BCA & ACCESS 2019 A1 INDICATIVE COMPLIANCE REPORT FOR DA LODGEMENT

**27 Albert Road,
Strathfield NSW 2135**

**DA2020/156
25 February 2021**

Prepared for: Cairich Enterprise Pty Ltd
Project No.: PRO-05130-H6Z0
Date: 22/02/2021
Status: Report Issue v2.0

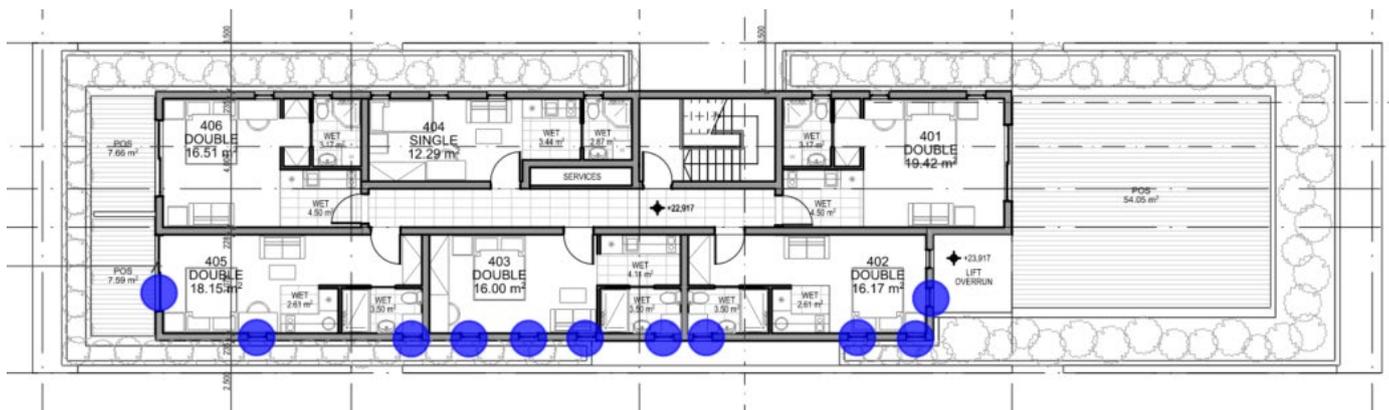
- 3x south-western facing external wall openings of Rooms 107, 207 & 307;
- The north-western facing external wall opening of Rooms 108, 208 & 308;
- 2x north-eastern facing external wall openings of Rooms 108, 208 & 308;
- The south-eastern facing external wall opening of Rooms 108, 208 & 308;
- The north-western facing external wall opening of Rooms 109, 209 & 309;
- The south-western facing external wall opening of the ensuite within Room 109, 209 & 309;
- The north-western facing external wall opening of Room 111, 211 & 311; and
- The north-eastern facing external wall opening of the ensuite within Room 111, 211 & 311.

- 3x south-western facing external wall openings of Room 402;
- The south-eastern facing external wall opening of Room 402;
- 4x south-western facing external wall openings of Room 403;
- The north-western facing external wall opening of Room 405; and
- 2x south-western facing external wall openings of Room 405.

Compliance can be achieved via undertaking a fire engineering performance solution prior to the issue of the Construction Certificate.

First to Third Floors

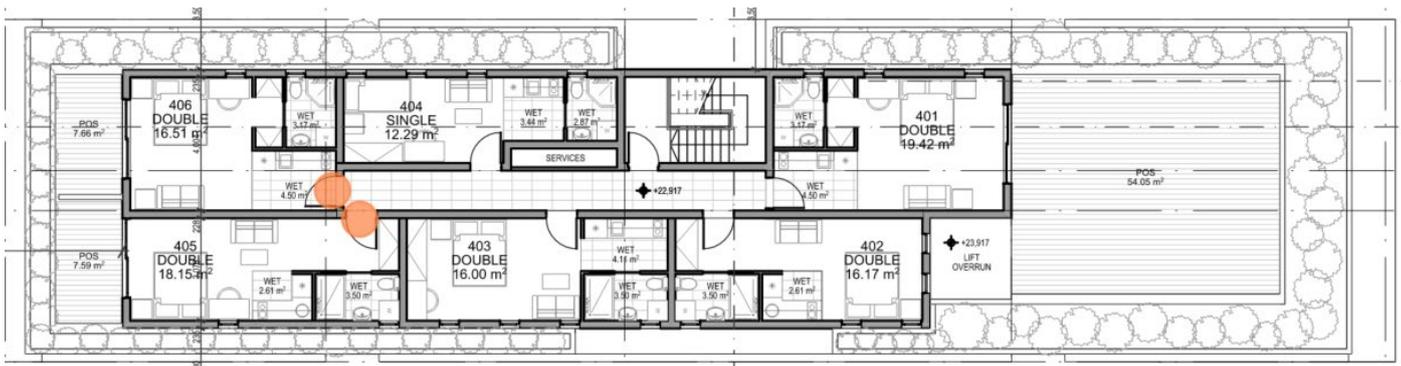
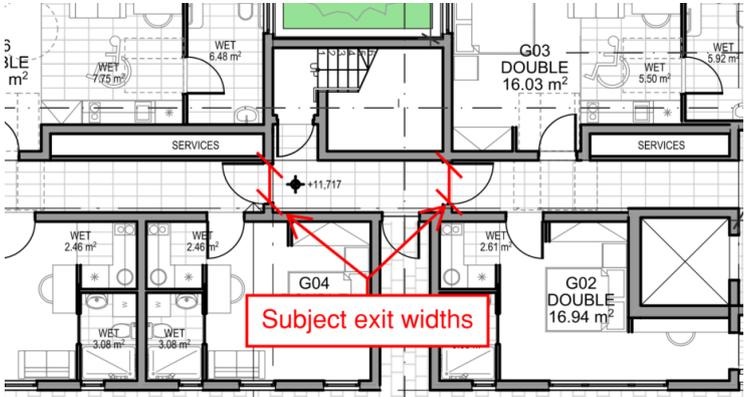
The following SOU's retain distances of up to 13.6m to a single exit in lieu of 6m and include:

- Units 101, 201 & 301;
- Units 102, 202 & 302;
- Units 103, 203 & 303;
- Units 109, 209 & 309;
- Units 110, 210 & 310; and
- Units 111, 211 & 311.

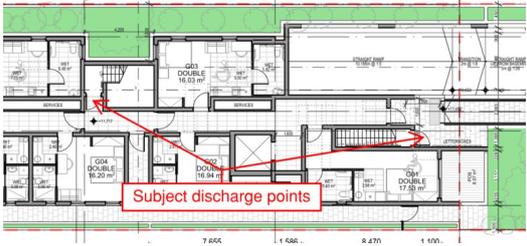
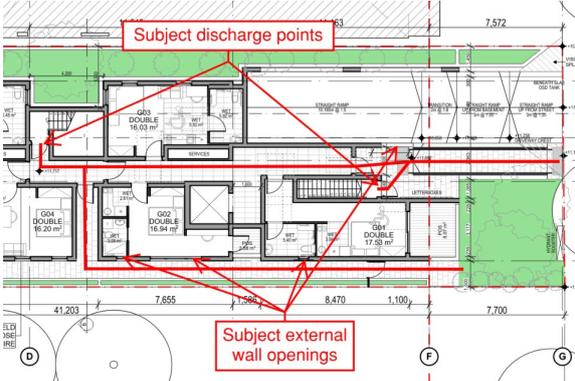
The following SOU's retain distances of up to 8.7m to a single exit in lieu of 6m and include:

- Unit 405 and;
- Unit 406.
